APPEAL SUMMARY

Appeal ID: 32102	Project Address: 820 and 830 SW Gaines St
Hearing Date: 1/31/24	Appellant Name: Tom Jaleski
Case No.: B-002	Appellant Phone: 971-238-5266
Appeal Type: Building	Plans Examiner/Inspector: N/A
Project Type: Commercial	Stories: 1 Occupancy: S-1 Construction Type: V-B
Building/Business Name: Oregon Health and Science University (OHSU) South Marquam Maintenance Facility Yards Building 1	Fire Sprinklers: No
Appeal Involves: Alteration of an existing structure, Reconsideration of appeal	LUR or Permit Application No.: EA-23-021714
Plan Submitted Option: pdf [File 1] [File 2] [File 3] [File 4]	Proposed use: Storage for Grounds Maintenance

OHSU SOUTH MARQUAM HILL NCU SITE UPGRADES

1 SITE PLAN
1/16" = 1'-0"

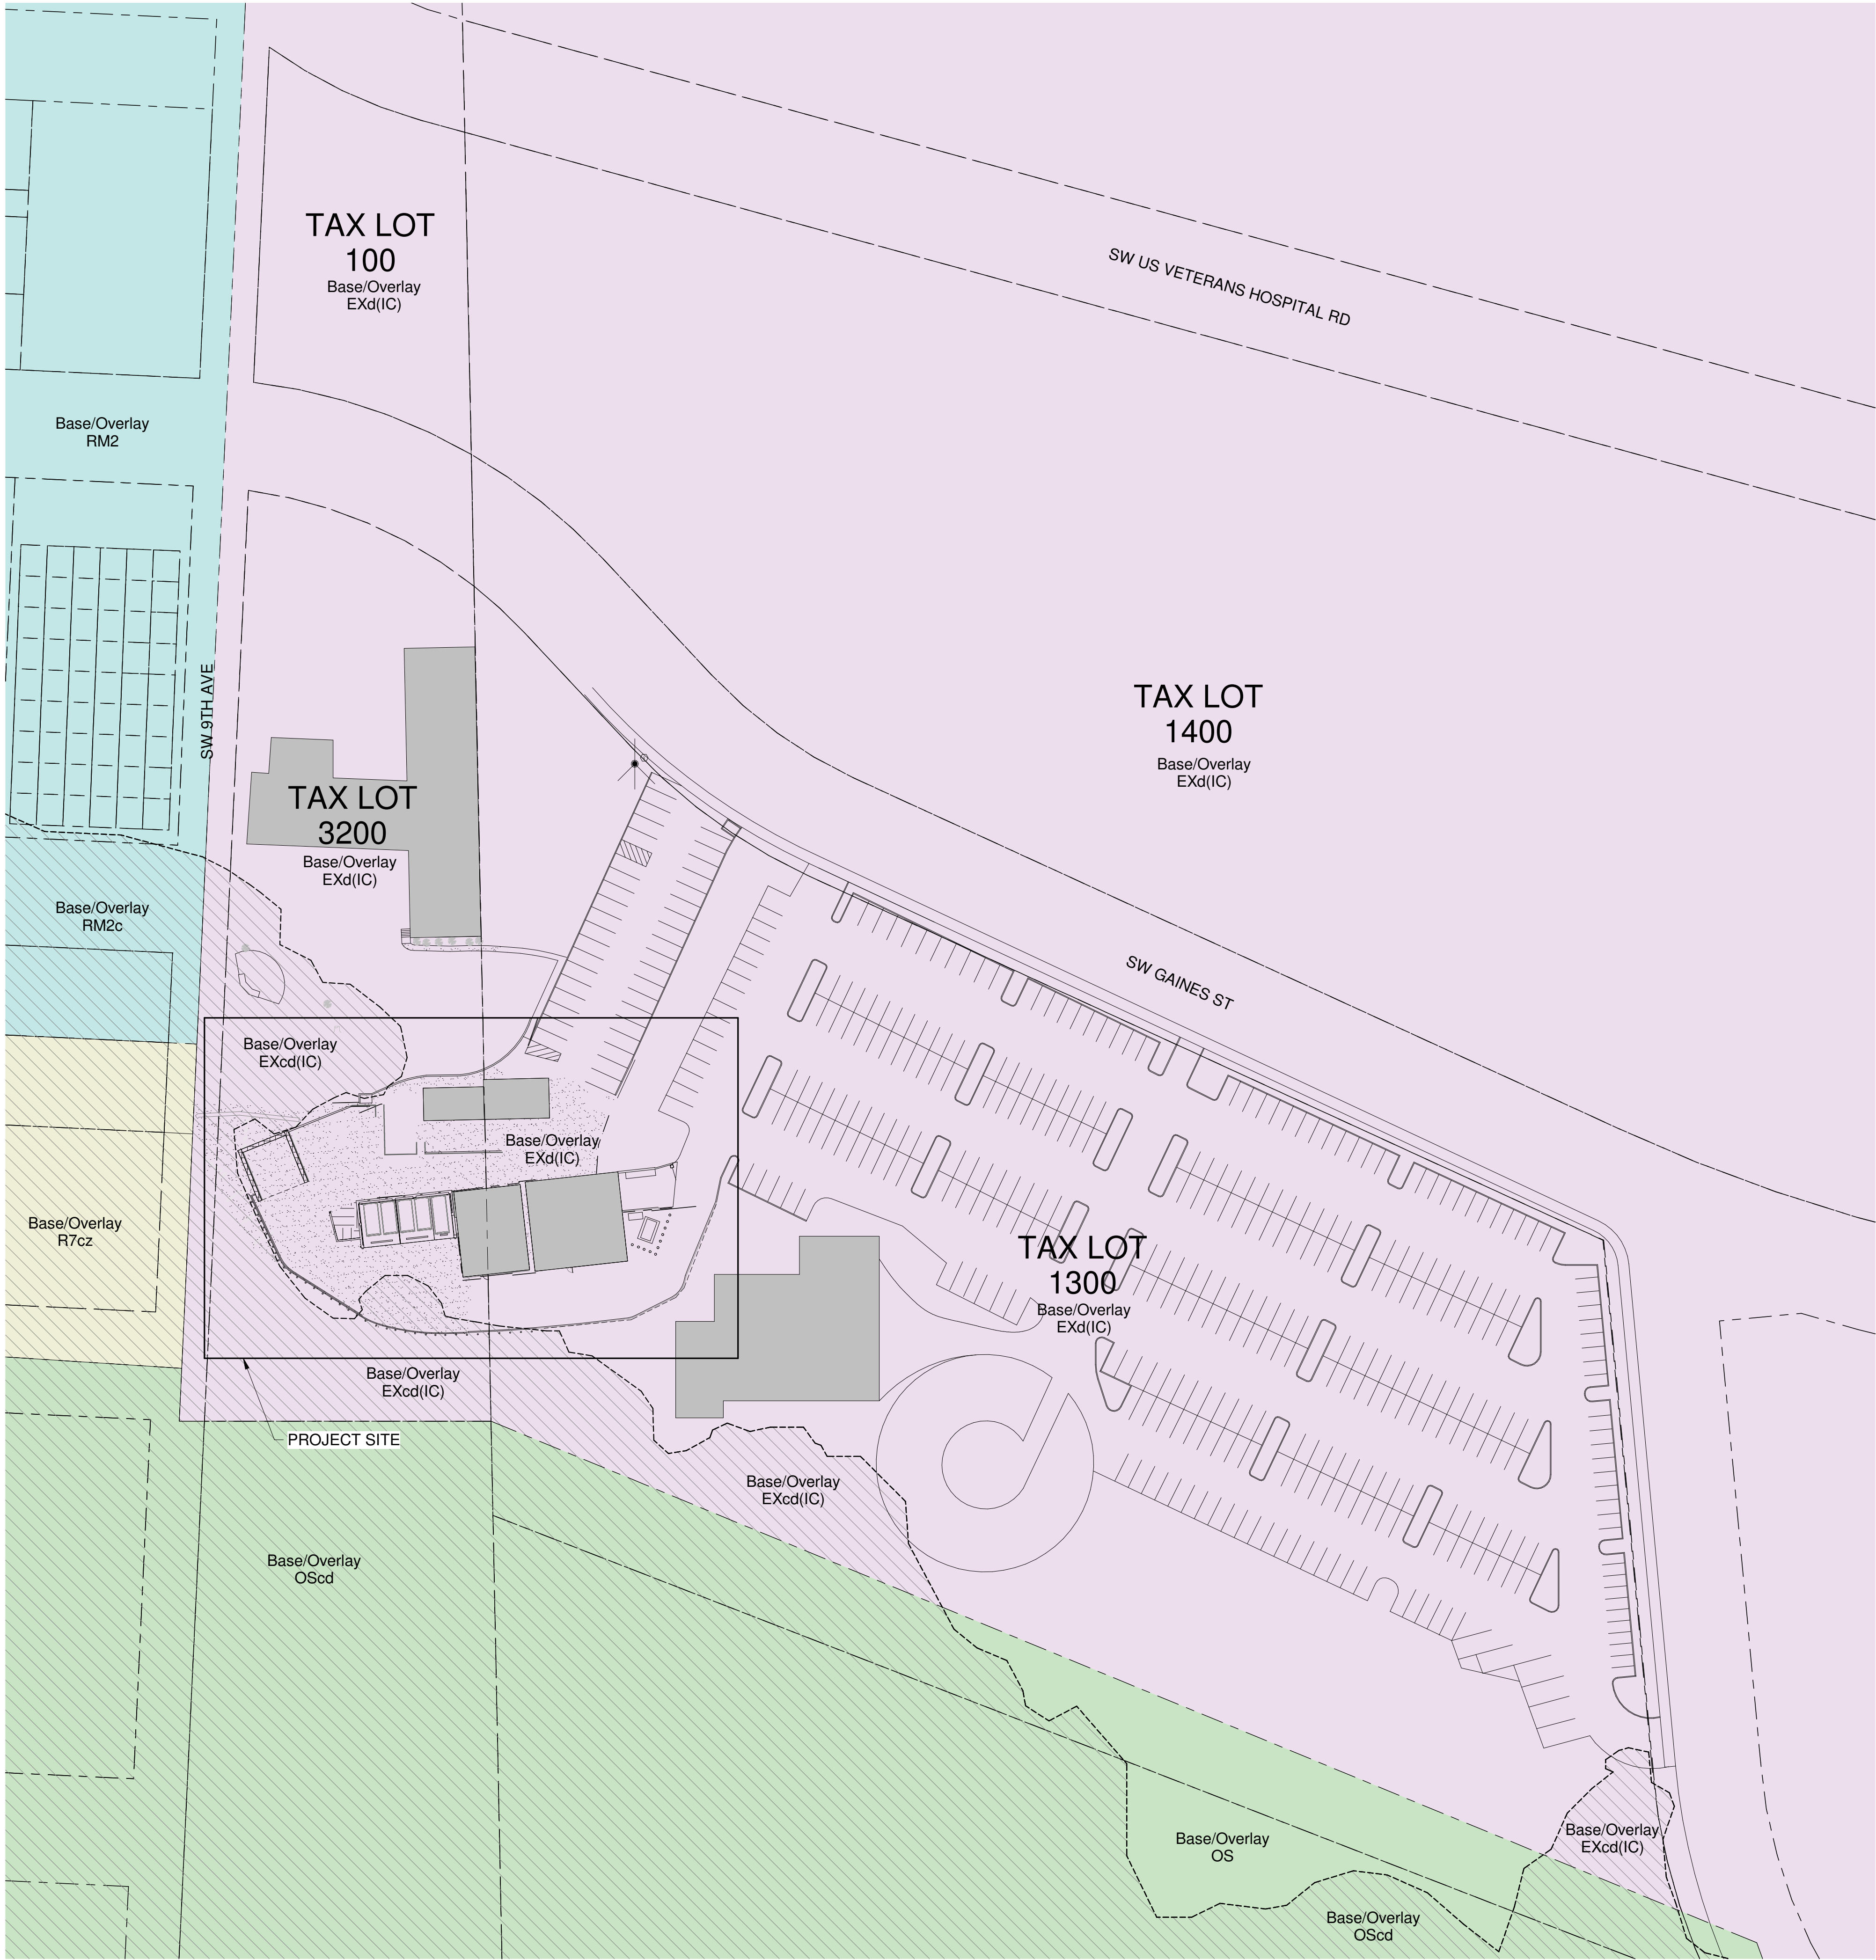
The original appeal is being re-submitted for each building on the lot. Building 1 at the South Marquam Maintenance Facility Yards is an existing unpermitted structure used for covered gravel storage. It is composed of Ultrablock walls with a membrane structure above. Under the scope of this project, the structure will be relocated within approximately 30 feet of its original location and permitted as a Type V-B, Group S-1 occupancy building but will otherwise remain as existing.

The structure does not meet current seismic design requirements of ASCE 7-16. However, the existing building meets the intent of City Code Chapter 24.85.010 Scope Section A to not require seismic upgrades even though it was not previously permitted.

Building 1 is not undergoing a change of occupancy, addition, or repair. The building will continue to be used as covered gravel storage and remain unoccupied except when maintenance employees are actively accessing or storing gravel (see image in Attachment C). The building is separate from other structures on the lot.

The structure has a calculated occupant load of 3 occupants, if it were not filled with gravel, which is significantly less than the 149 occupant load increase allowed without seismic improvements by City Code Chapter 24.85.040. Therefore, not requiring seismic upgrades provides equivalent protection to what is currently allowed by City Code.

The Covered Gravel Storage (Building 1) will be moved outside of the environmental zone in the scope of this project but will otherwise remain as existing. The existing building is constructed of concrete Ultrablock walls that are stacked concrete units with no additional reinforcement. These will be unstacked in their current location and re-stacked, as previously stacked, in the new location. The cover will also be removed and re-attached as originally attached with new anchors.

Code compliance is provided by OSSC §3414.1, which refers to §3403.3.1, which states the structure only needs to meet the requirements at the time of construction. Though the original seismic design requirements are not recorded, the current structural engineer will design footings/soil bearings at the new location support the existing building when relocated so that new foundations will meet current code requirements.

Building 1 at the South Marquam Maintenance Facility Yards is an existing unpermitted structure used for covered gravel storage. Under the scope of this project, the structure will be relocated within approximately 30 feet of its original location and permitted as a Type V-B, Group S-1 occupancy building but will otherwise remain as existing.

In addition to the code path described below, accessible restrooms will be provided within 300' of the relocated position of Building 1. The proposed relocation of the structure does not decrease the accessible access to the accessible restroom facilities, which were not along an accessible grade originally.

1) Allow gravel storage building to be moved without requiring seismic upgrade: Granted provided canopy is anchored to concrete block walls to meet current code.

2) Omission of access to a restroom for gravel storage building: Granted as proposed.
